Subject: Response to Review Comments
Geologic Hazards Evaluation and Preliminary Geotechnical Investigation
Mayberry, 540 Acre Site, PUD2
Highway 94 and Log Road
El Paso County, Colorado
CTL|T Project No. CS18969.004-105-L1 Rev

The following are a summary of the review comments and our responses.

Topography of Mayberry Site and Surrounding Area

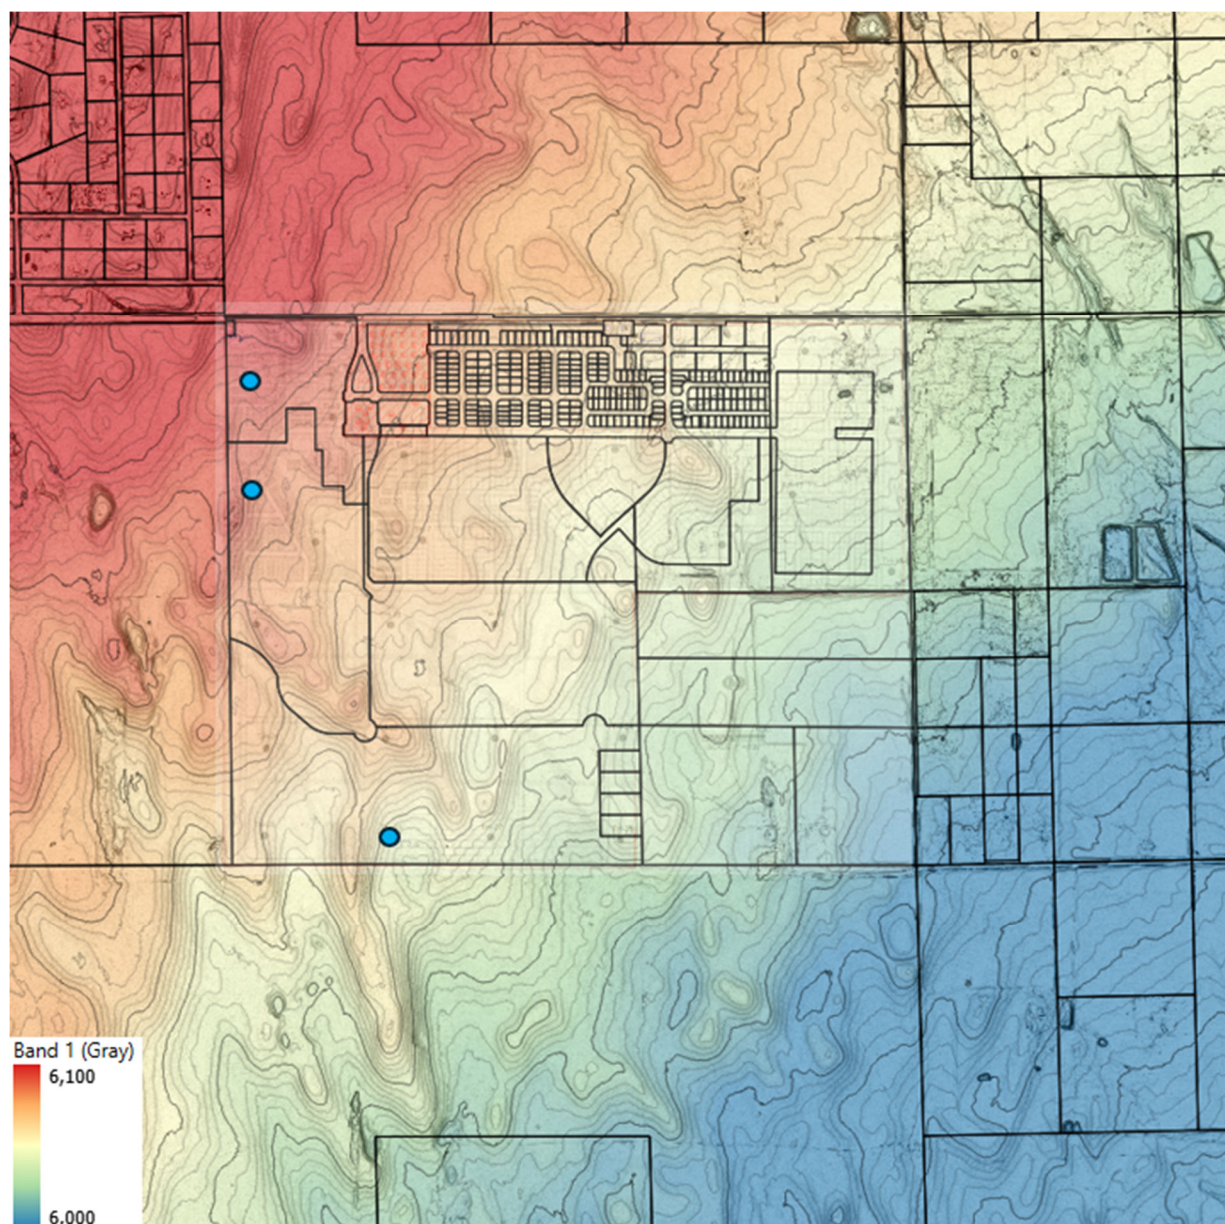
July 2026 CGS Comment:

“As stated in our previous review (October 22, 2025), if basements are planned, CGS recommends that the [C]ounty require groundwater monitoring/observation to verify that proposed floor levels are at least three feet above maximum anticipated groundwater levels and maintained year-round. This monitoring/observation program should be conducted immediately and/or before the installation of public infrastructure to determine if basements are feasible. CGS recommends no below-grade construction unless a groundwater monitoring/observation program is implemented.”

The CGS recommendation for a groundwater monitoring/observation program is excessive and unwarranted. Our firm has advanced over 100 borings at the Mayberry site during the past 6 years. Shallow groundwater has not been identified as a geologic hazard or engineering constraint. We have reviewed historic aerial imagery of the site and conducted numerous site visits. No surface evidence of springs or seeps were found. No channelized drainages were observed within the site. Localized groundwater greater than 10 feet below the surface and outside of the PUD2 project limits does not justify a costly groundwater monitoring program that would delay development for over a year. An elevation shaded DEM overlaying a slope shaded DEM of the Mayberry Site with 2-foot contours generated from the 2018 3DEP East CO El Paso 1-meter resolution Lidar is provided below. The three borings where groundwater was encountered are indicated with blue dots.

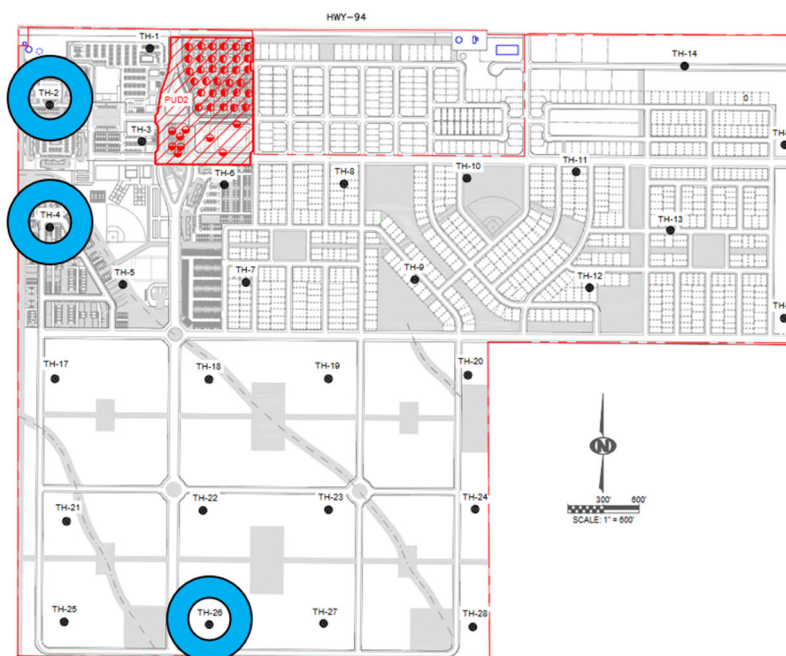
July 2026 CGS Comment:

Regarding the CTL Thompson report (March 13, 2023):

“Additionally groundwater was encountered in CTL’s borings at depths of 10.5 to 15 feet within the western portion of the Mayberry development.”

This investigation (CTL|T Project No. CS18969.00-105) that covers the 540-acre site, including PUD2, had three borings in which we observed groundwater. The boring numbers are TH-2, TH-4, and TH-26. These three borings lie along the western edge (TH-2 and TH-4) and southern edge (TH-26) of the overall development, and are well outside of the boundary of PUD2. A screenshot of the revised Fig. 1 (attached) with the locations of borings TH-2, TH-4, and TH-26 (circled in light blue) relative to the location of PUD2 (outlined in red) within the overall development is included below:

Shallow groundwater was not identified within PUD2, therefore, it does not require mitigation measures.

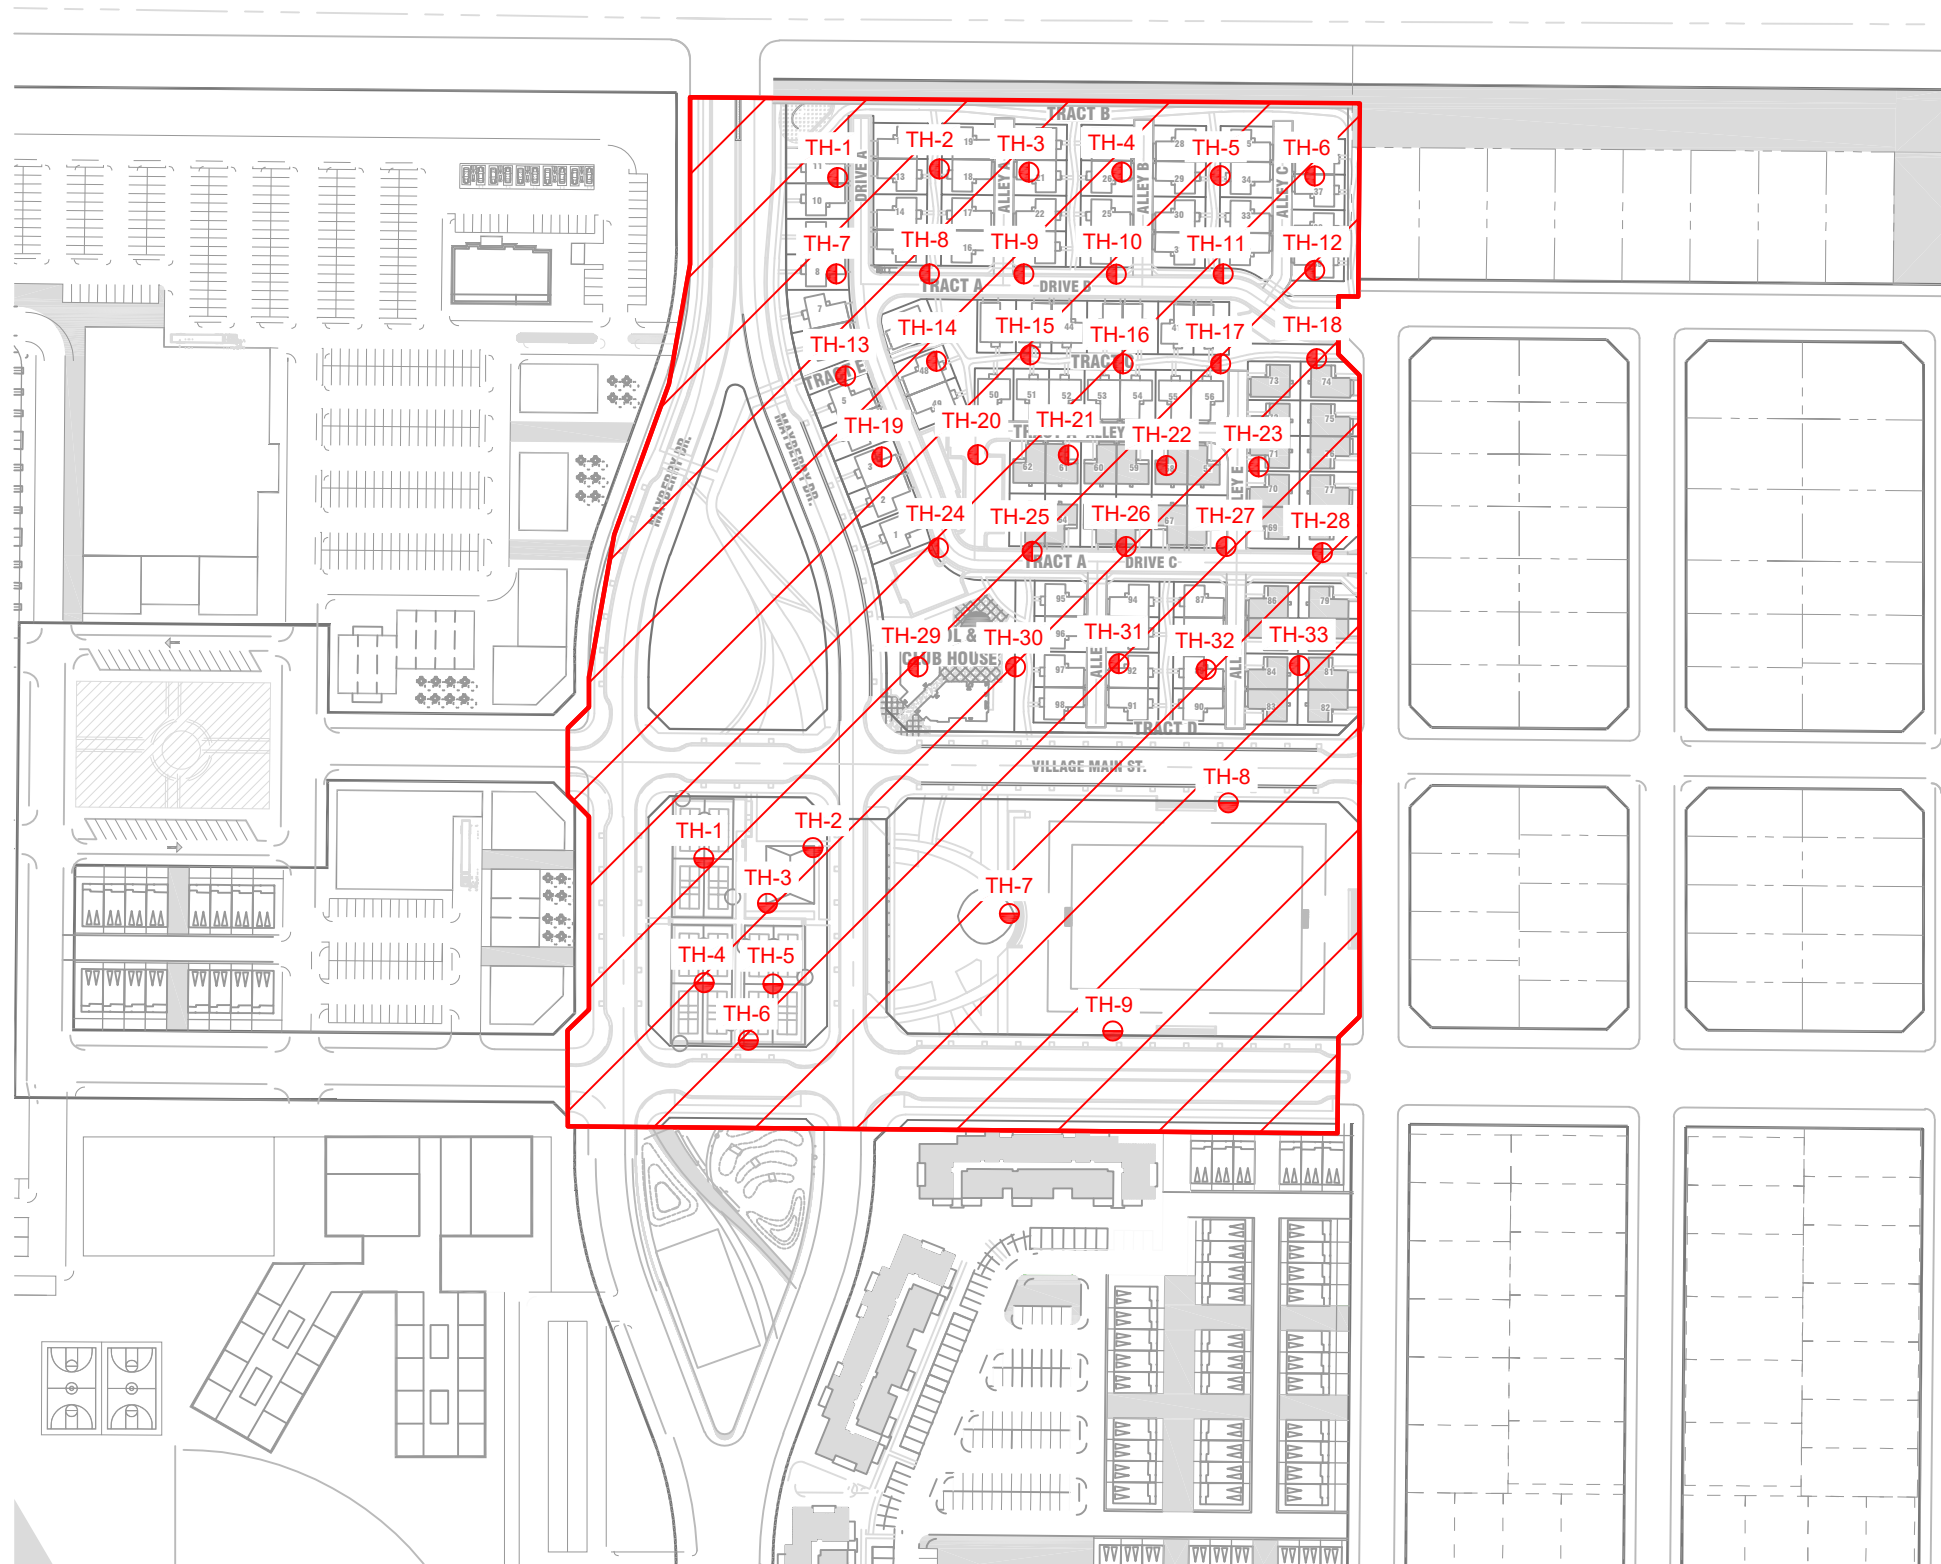
And October 2025 Review Comment in blue text box on Fig. 1 of our report:

"Call out the specific project area for Mayberry PUD 2 with a boundary"

PUD2 is a part of the 540-Acre Site, which is covered by this report. We have revised Figure 1 to include a boundary for PUD2 and we have added a Figure 2, which is a detail of the PUD2 area from Figure 1, since the PUD2 area is relatively small compared to the overall 540 Acre site.

CTL|T has conducted two additional design level investigations within PUD2. We have revised Figure 1 to include an indication of the locations of the borings for the PUD2 investigations, and the laboratory testing is included in Appendices A and B of this letter. No groundwater was encountered in these investigations.
